REQUEST FOR COUNCIL ACTION

AGENDA SECTION: CONTINUED - PUBLIC HEARINGS	ORIGINATING DEPT: PLANNING	ITEM NO. E-4
ITEM DESCRIPTION: General Development Plan #199 to be known as 37 th Street Commercial Park. The Plan proposes to develop approximately 55 acres of land zoned B-4 (General Commercial), located east of the Zumbro River, west of East River Road NE and south of 37 th St. NE. The Plan proposes public roadways with access to 37 th Street and East River Road, and proposes multiple lots for commercial development.		PREPARED BY: Mitzi A. Baker, Senior Planner

GENERAL DEVELOPMENT PLAN

RE: Supplementary Material for Review of Traffic Impact related to 37th St Commercial Park

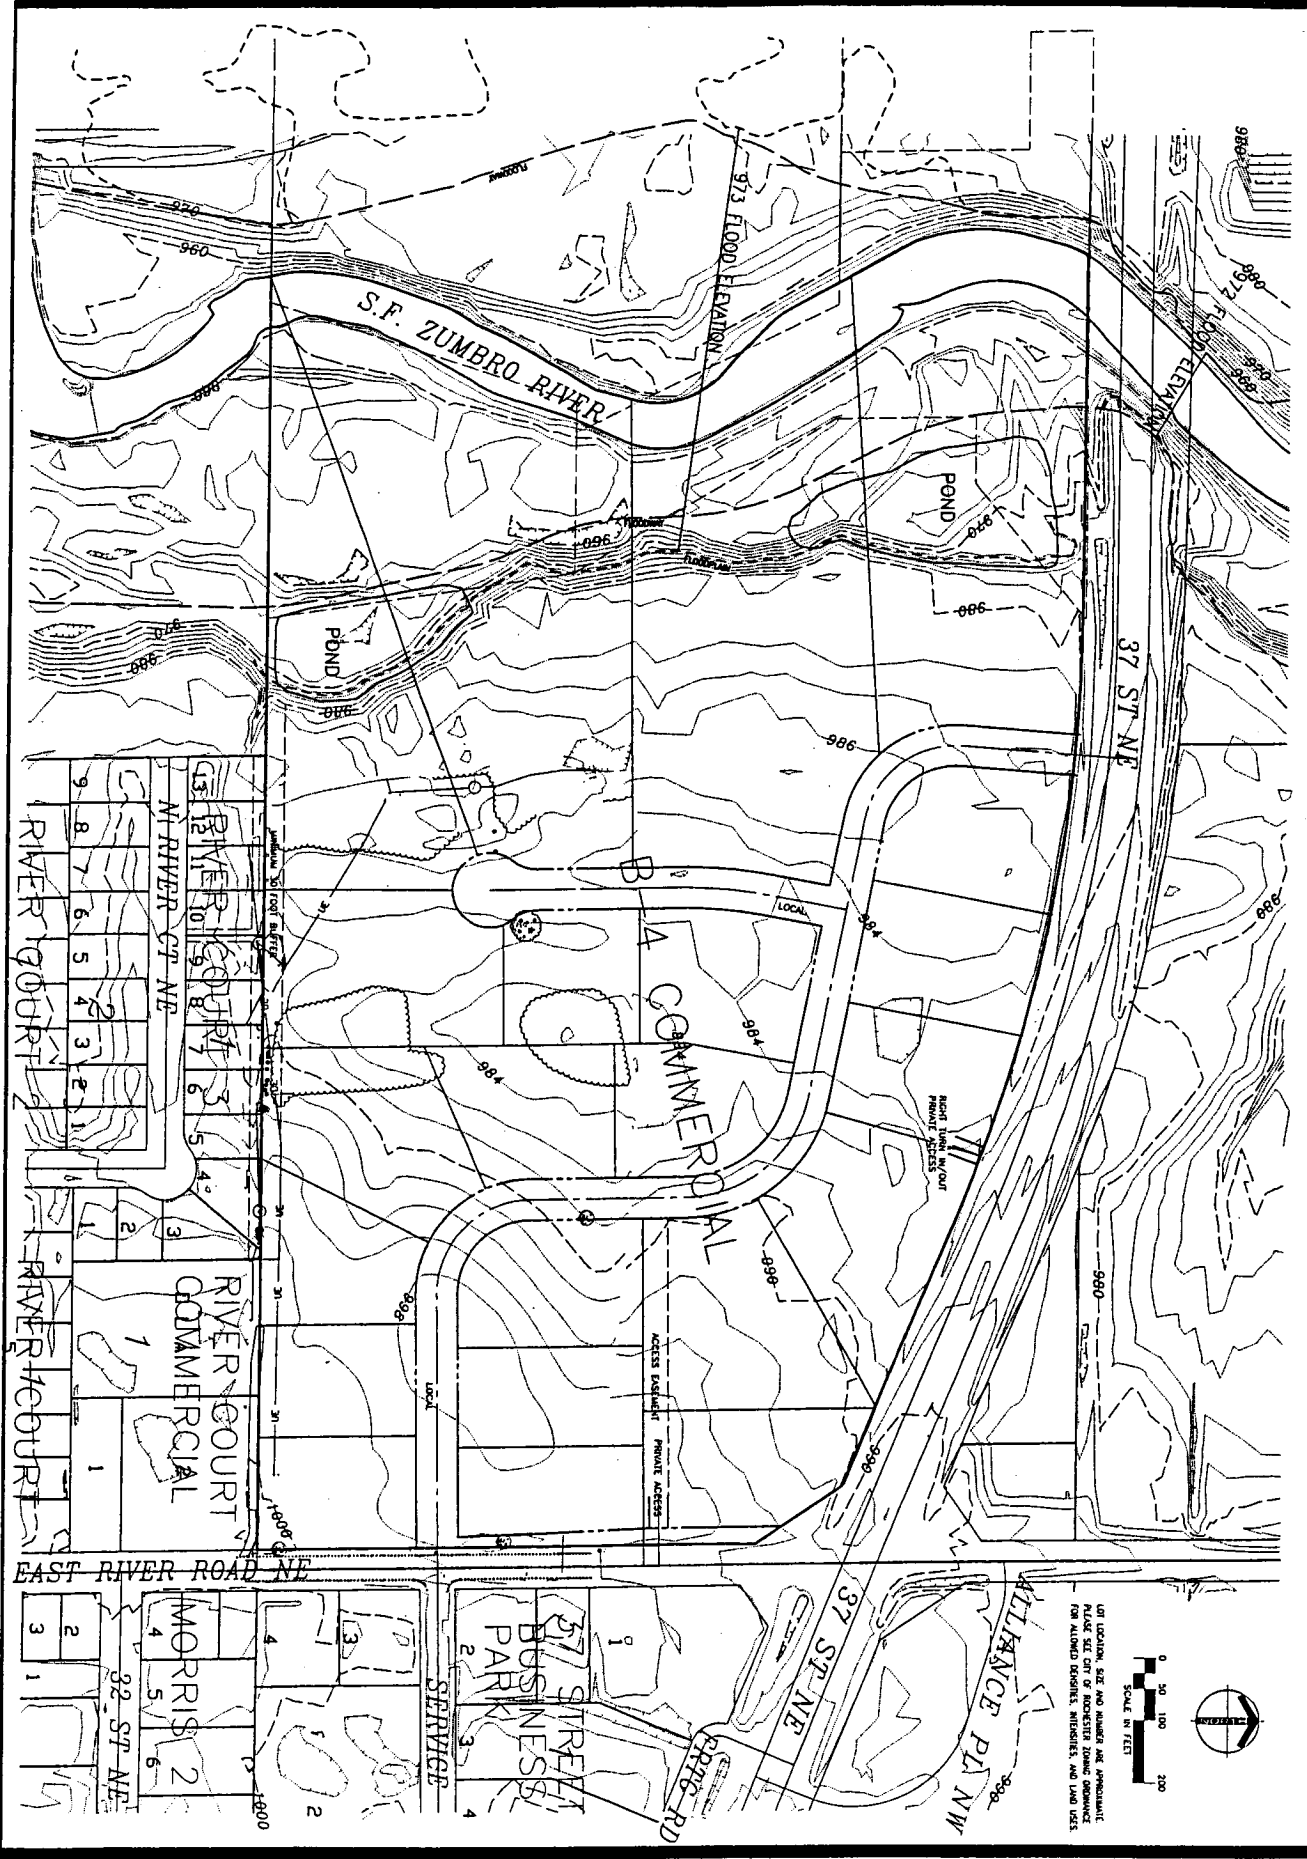
1. *The GDP shall be revised to eliminate the right in/out access to 37th Street.*
2. *This property must be platted prior to development. At the time of platting, 1) additional right-of-way may need to be dedicated for 37th Street and East River Road, 2) controlled access will need to be dedicated for the frontage along 37th Street, except for the one public street opening, and also along East River Road except for the approved driveway and public street opening, 3) the applicant shall dedicate a drainage easement over the 100 year floodplain where elevation will be at or below the 100 yr flood elevation following grading of the property 4) the applicant shall dedicate a 30' wide pedestrian Outlot in the Floodway designated area, to the City, for future trail access to 37th Street from the residential area to the south.*

6. *Pedestrian facilities will be required along both sides of the public roadways and also along the entire frontage abutting East River Road.*
7. *The final median design on 37th Street has not been determined. Final design for modifications to 37th Street and East River Road must be approved by the road authorities prior to development of the property. The timing and phasing of development relative to roadway improvements must also be finalized.*

8. *The proposed private access to East River Road will be limited to right in/out only and may require the construction of a median in East River Road, or other methods to limit traffic movement, based on results of Traffic Impact Report.*

Figure 1: Proposed West Access Layout

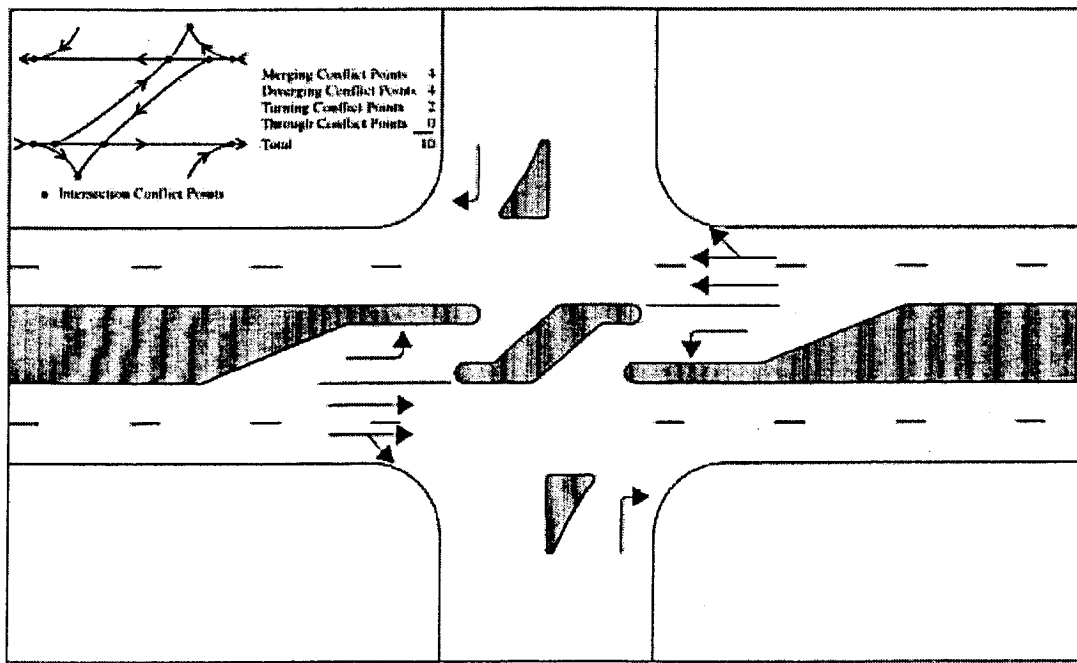
- Based on that scenario and staff's perspective that the 37th St corridor should be managed to permit traffic to flow at speeds typical of high end arterial corridors (40mph +/-); and that efforts need to be made to retain east-west traffic capacity to the extent possible while balancing the need for access, staff recommended the following access improvements:

- a ¾ access as illustrated below at the west access point
 - a five lane section on the south leg of the intersection at East River Road and 37th St including 3 northbound lanes and 2 southbound lanes
